FINDINGS

Subject to the conditions contained herein, the proposal is consistent with the requirements for approval of the proposed Specific Parcel Master Plan amendment applications contained in Section 65.336 of the Land Development Code (LDC) :

CONDITIONS OF APPROVAL

EXHIBIT A: OVERALL SITE PLAN

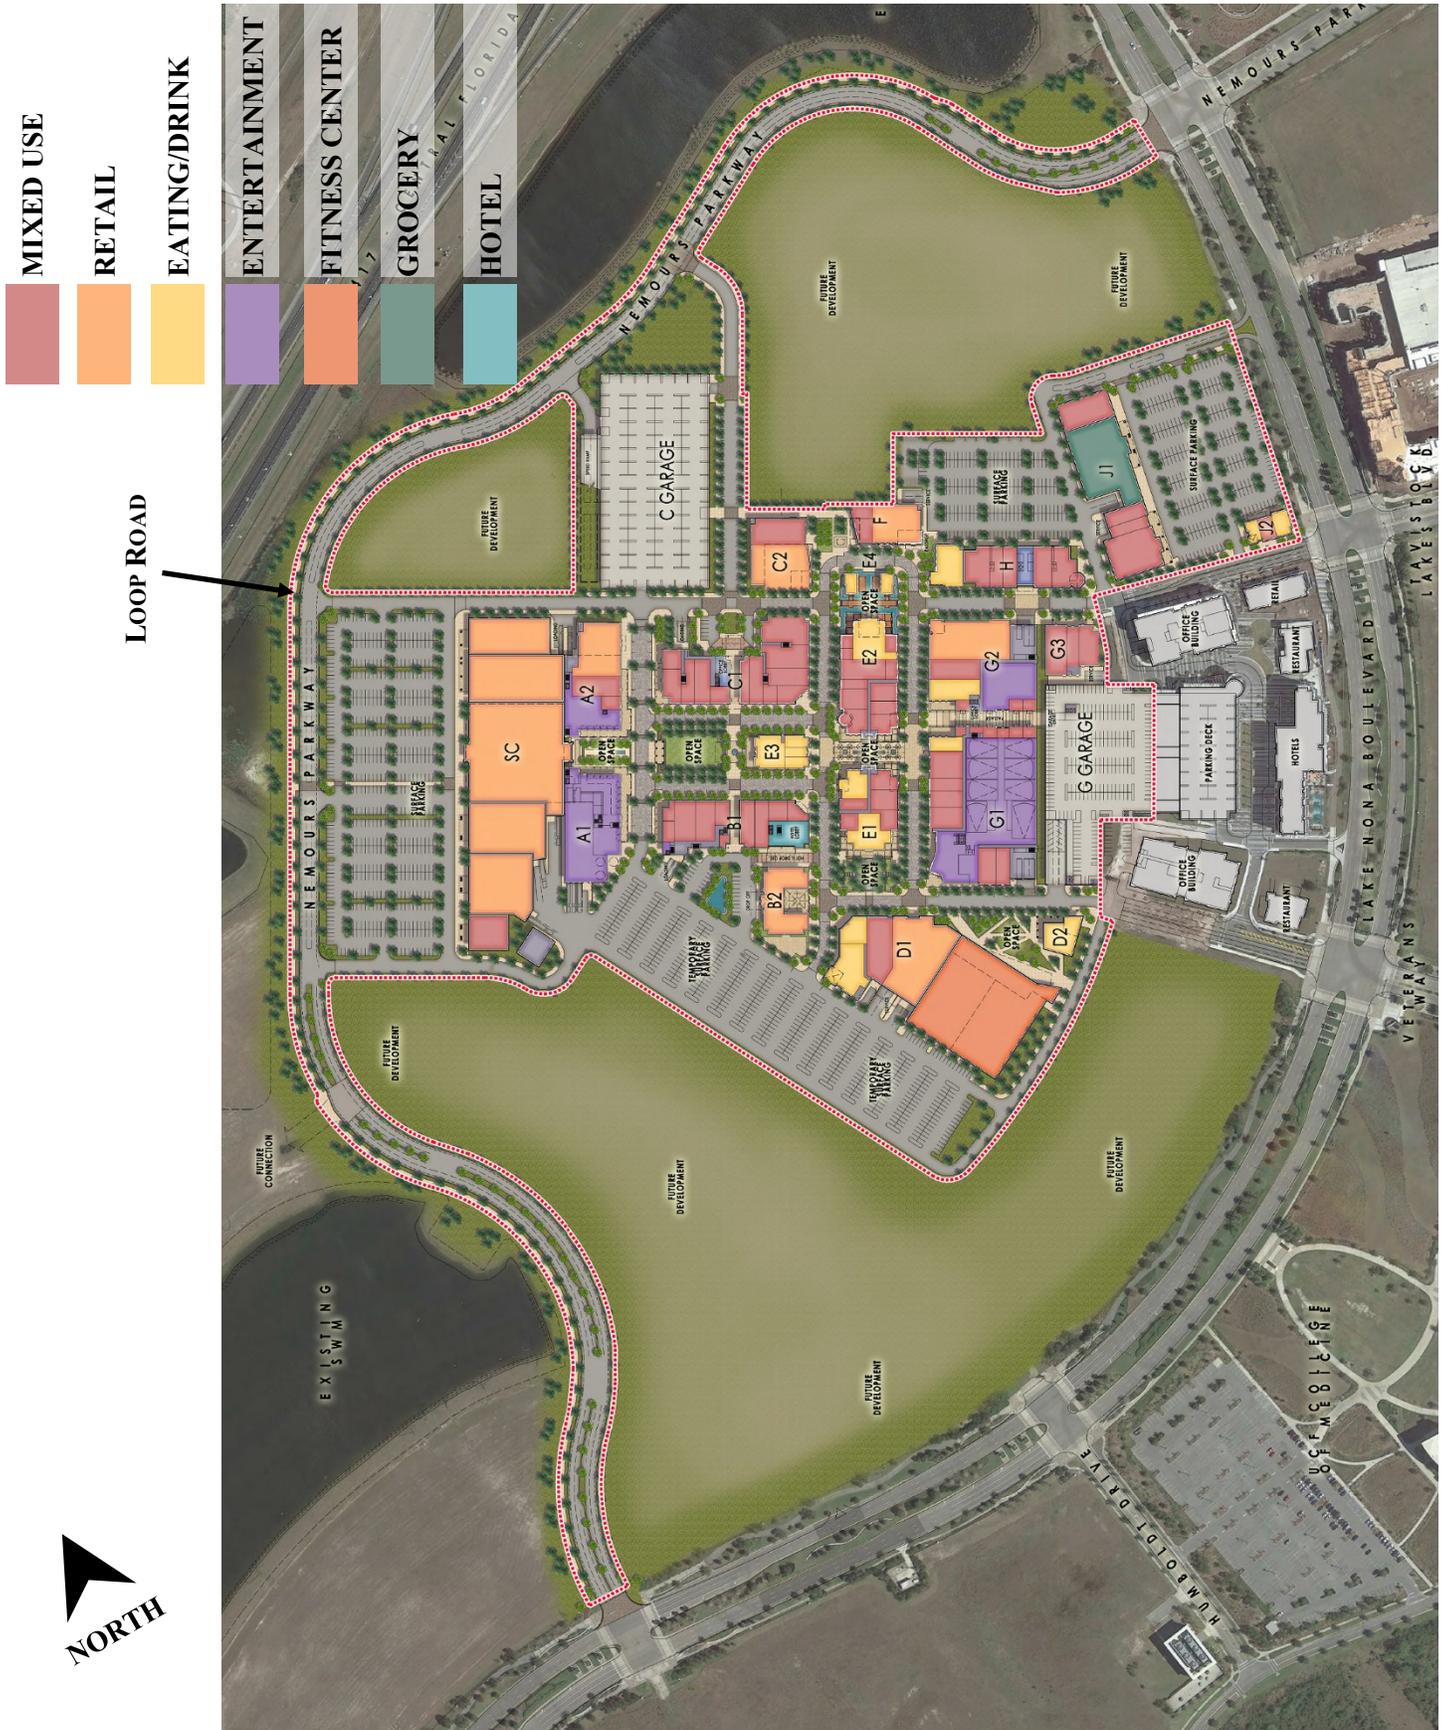
A revised overall site plan shall be required as a stand alone determination prior to submittal of the first vertical development determination request. The following site plan revisions are required:

Civic and green space—The site plan and development program will include a minimum 10% Civic/green space uses.

Temporary parking lot—While specific pedestrian connections shall be built during the associated phase of construction, to create a sense of community, and promote logical street and sidewalk network to surrounding uses all requirements of LDC Section 61.314 shall apply to all phases. Understory trees such as crepe myrtles and palms can be uses in parking lot islands for future removal and relocating elsewhere on the site once the parking lot redevelops. Crosswalks connecting pedestrian walkways across parking lot drive aisles shall be designed and constructed to appear visually distinct from the adjacent driving surface through the use of colored or textured concrete.

Type 4 cross-section—With the expectation of future development, the ‘Type 4’ cross section should be used along the street adjacent to Buildings B1, B2, and D1. The streetscape for street Type 4 shall be built on the side adjacent to the buildings, but the other side may be designed as a drive aisle, to be upgraded in a future phase.

Parallel parking—Parking along the western side of ‘Building D1’ shall be parallel parking. The associated roadway shall be treated as a major roadway when future development is built.

Eliminate parking strip—Eliminate parking strip behind A1 and adjacent to the lift station in order to eliminate traffic conflicts by cars backing out into a main drive aisle. Replace parking with landscaping.

EXHIBIT C: BUILDING HEIGHTS PLAN

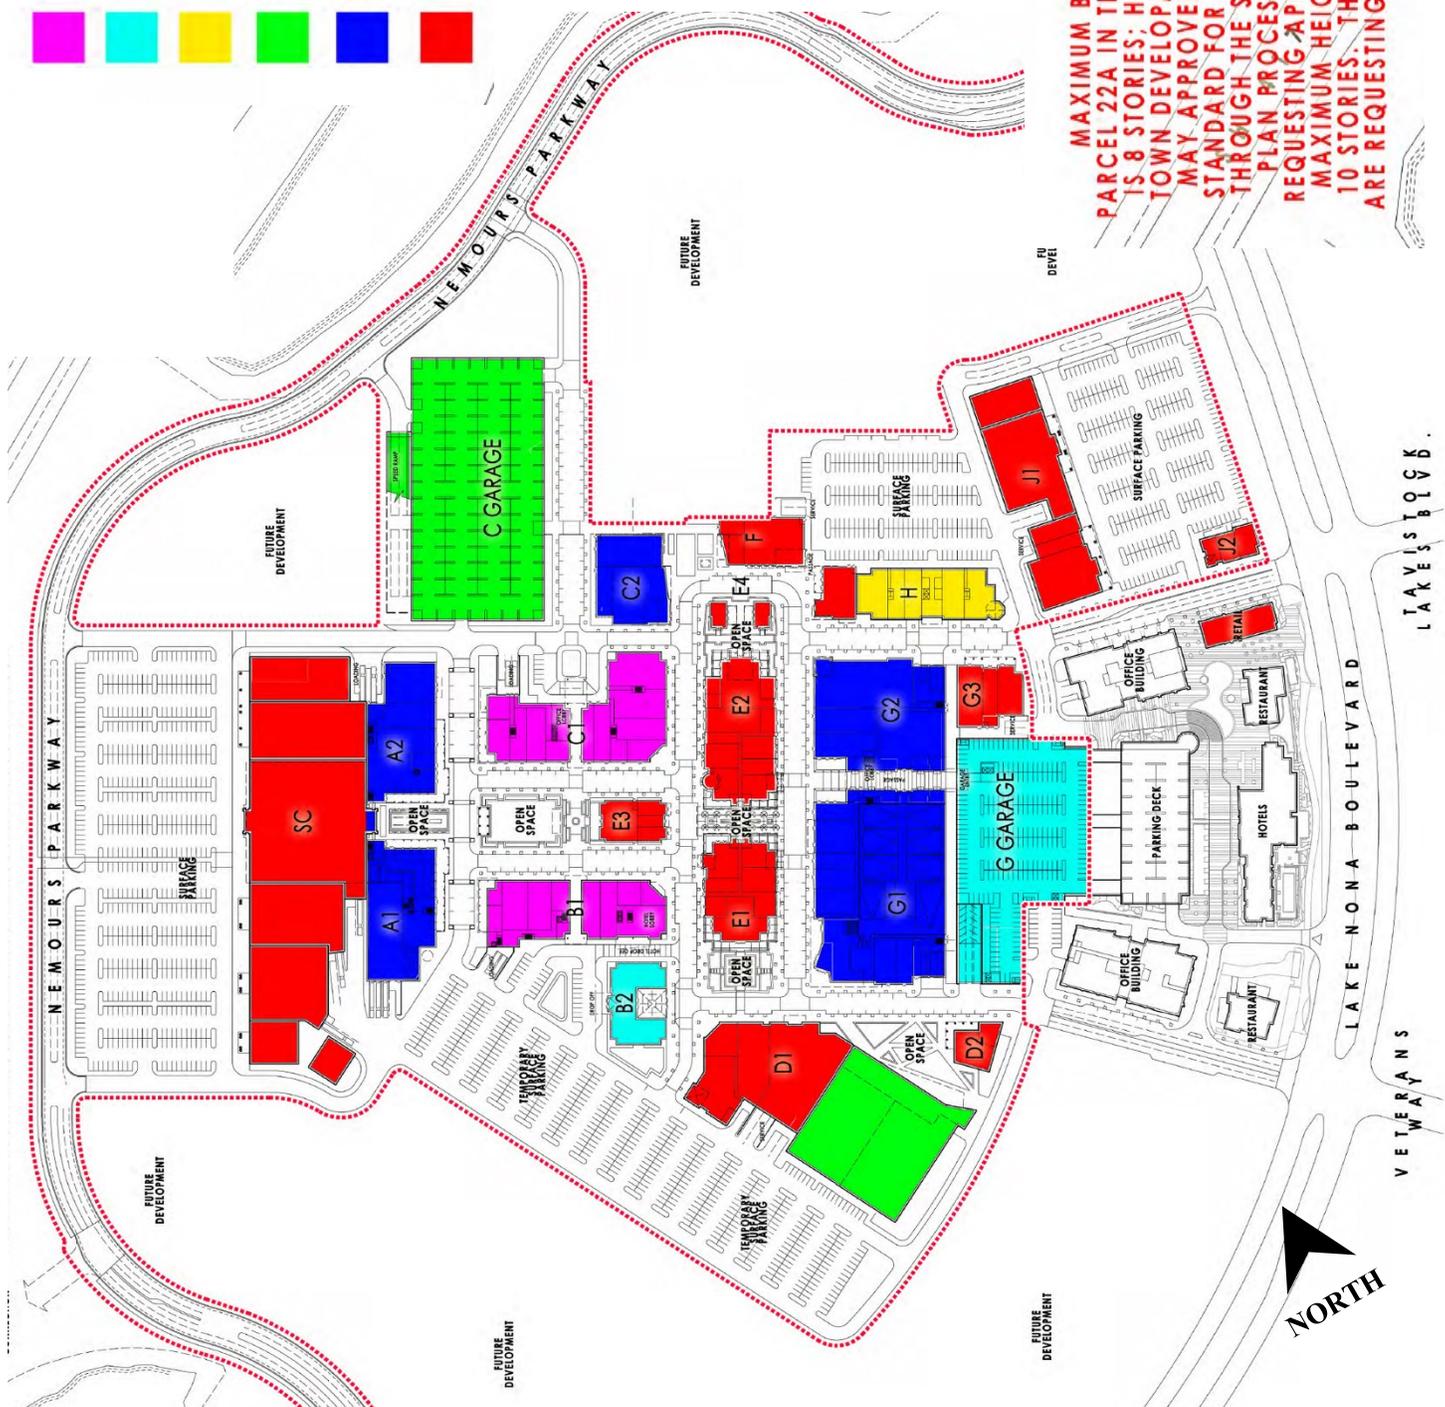
MAXIMUM BUILDING HEIGHT FOR PARCEL 22A IN THE PLANNED DEVELOPMENT IS 8 STOREYS; HOWEVER, THE SOUTHEAST TOWN DEVELOPMENT REVIEW COMMITTEE MAY APPROVE AN ALTERNATE HEIGHT STANDARD FOR ANY INDIVIDUAL PARCEL THROUGH THE SPECIFIC PARCEL MASTER PLAN PROCESS. THEREFORE, WE ARE REQUESTING APPROVAL FOR AN OVERALL MAXIMUM HEIGHT OF PARCEL 22 A OF 10 STOREYS. THROUGH THIS EXHIBIT, WE ARE REQUESTING THE INDIVIDUAL HEIGHTS SHOWN.

EXHIBIT F: LOOP ROAD TYPES (SECTIONS)

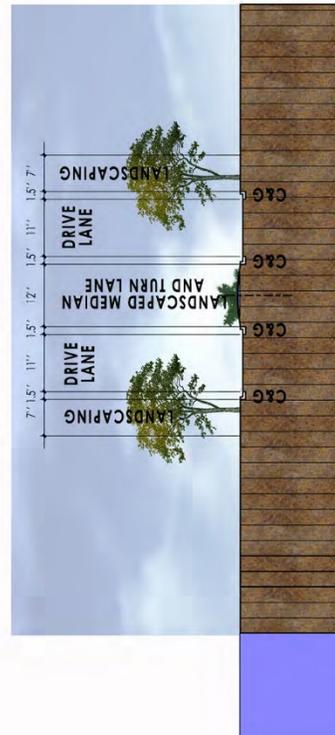
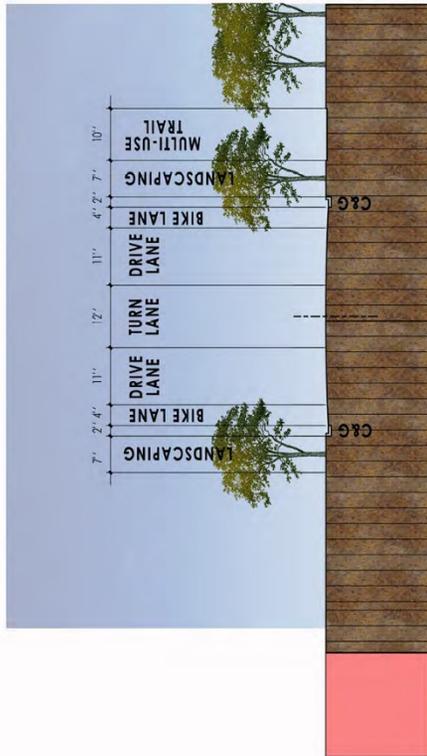
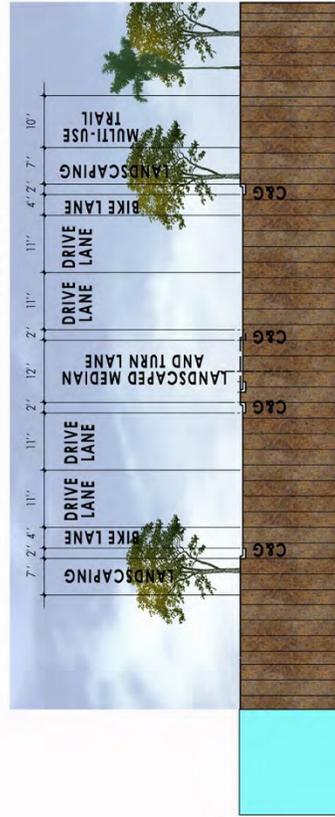
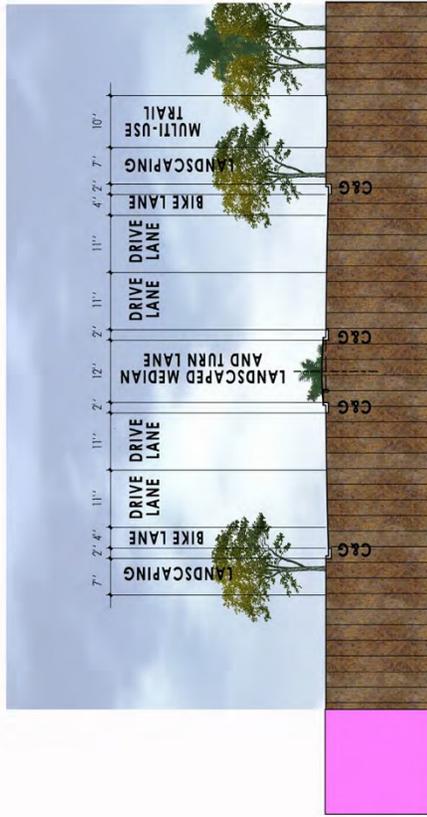
3. *LOOP ROAD MINIMUM ROW OF 75 FEET*

- The Loop Road will require a 10 foot travel lane, 5 foot bike lane, 2 foot Type F curb/gutter on each side, plus a 12 foot wide center turn lane/raised median. This results in 16 feet of clear path for emergency vehicles on each side of the median.
- Each median shall include mountable curbs and stabilized grass for four feet on each side to create the minimum 20 foot clear fire access path in each directions. Trees and shrubs are not permitted in the four foot clear area of the curb/median, however they are allowed in the center of the median subject to site visibility.
- The medians must be spaced to allow for fire access and may be no longer than 200 feet.
- The Loop Road shall also include a 5 foot wide sidewalk on the south/east side, a 10 foot wide shared-use path on the north/west side, and a 7 foot wide landscape buffer on each side.

4. *SECONDARY ACCESS ROAD (LOOP ROAD TYPE 2)*

The 'Secondary Access Road' shall meet the fire access widths for the median as described in TE Condition 3 above, or the median shall be removed.

EXHIBIT H: OPEN SPACE MAP

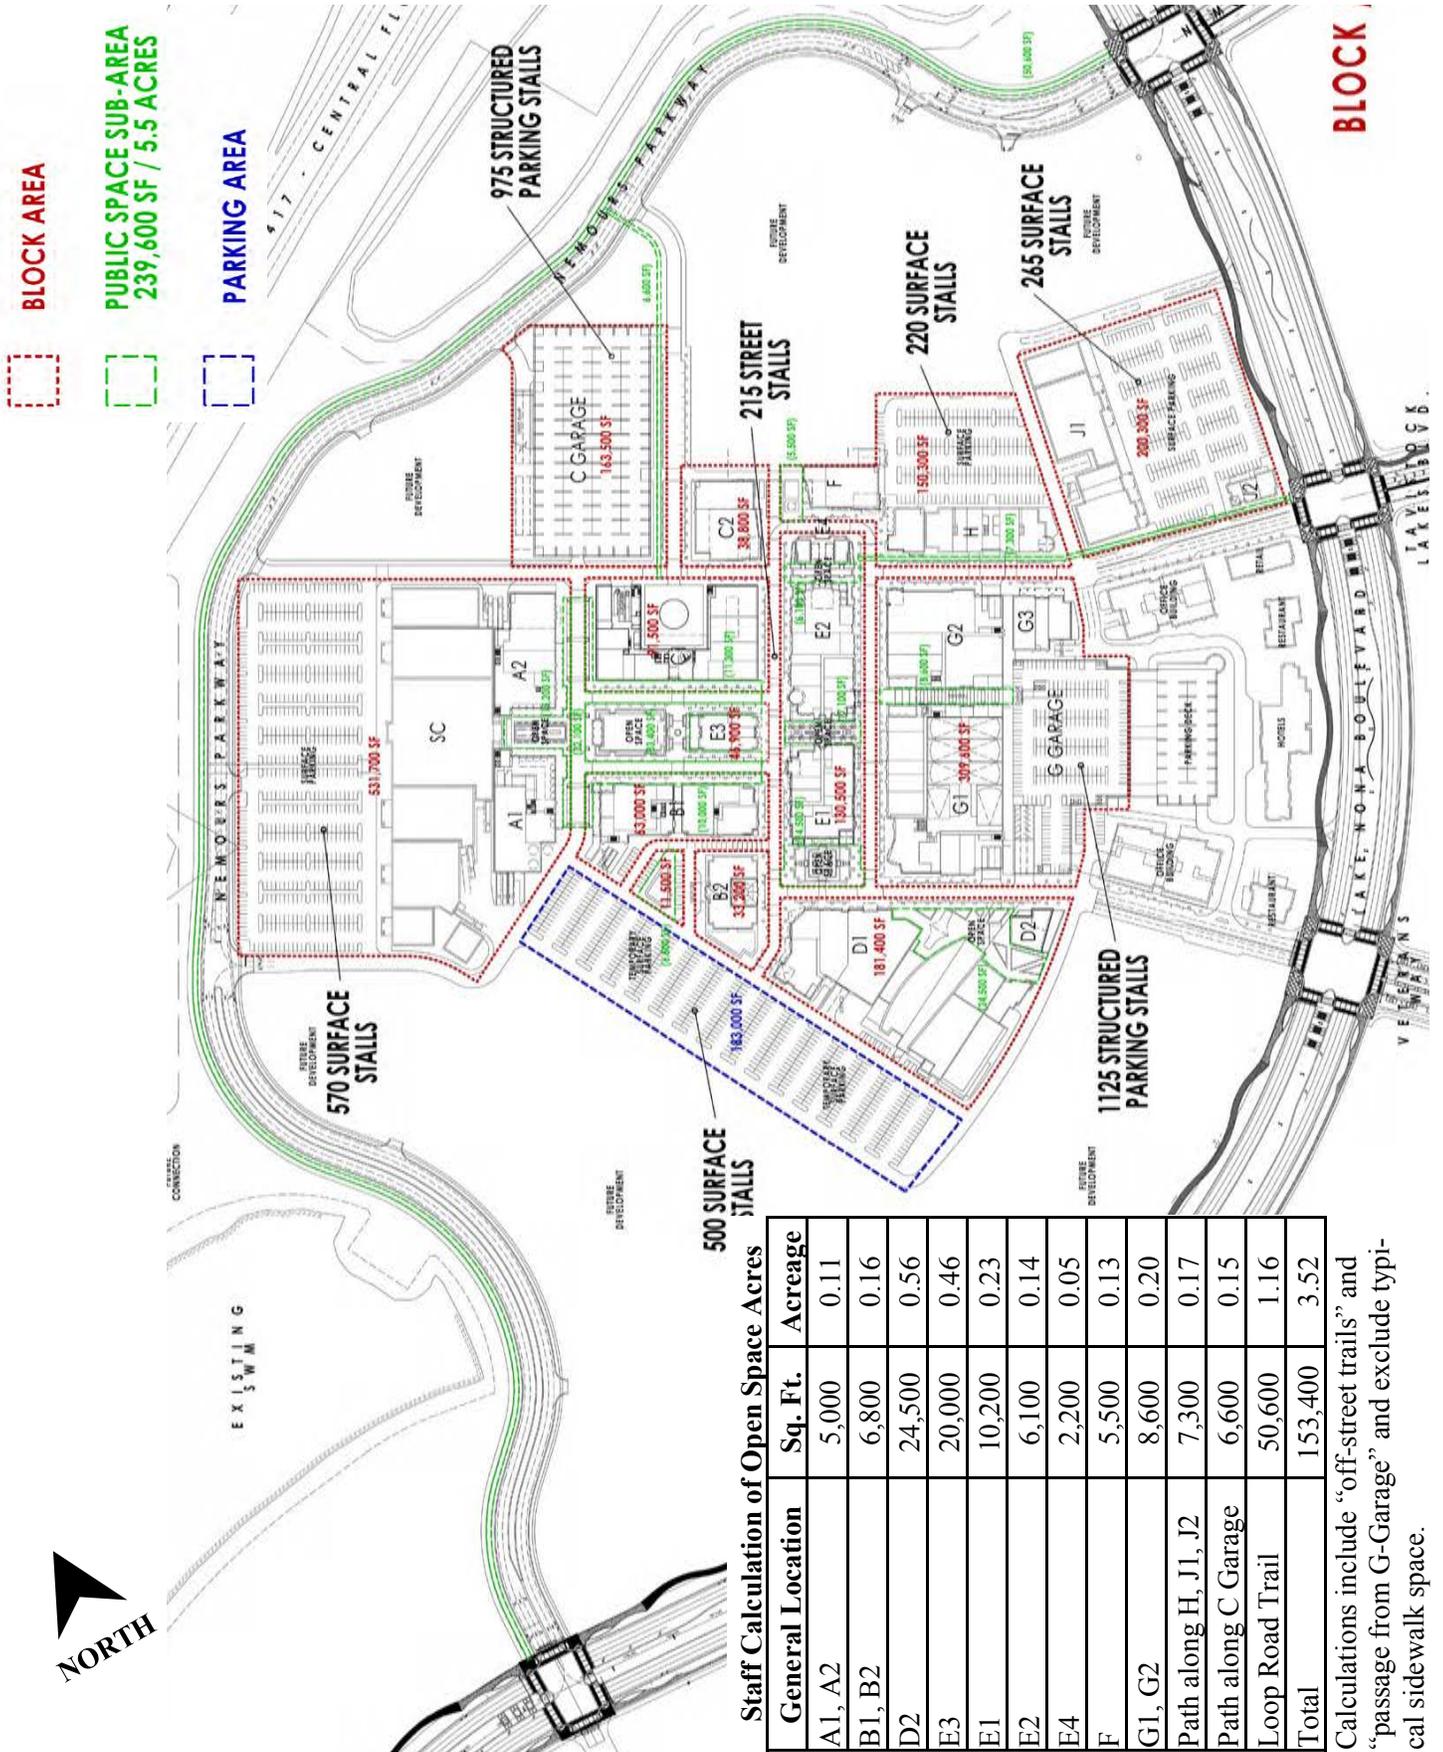
Staff Calculation of Open Space Acres

Calculations include “off-street trails” and “passage from G-Garage” and exclude typical sidewalk space.
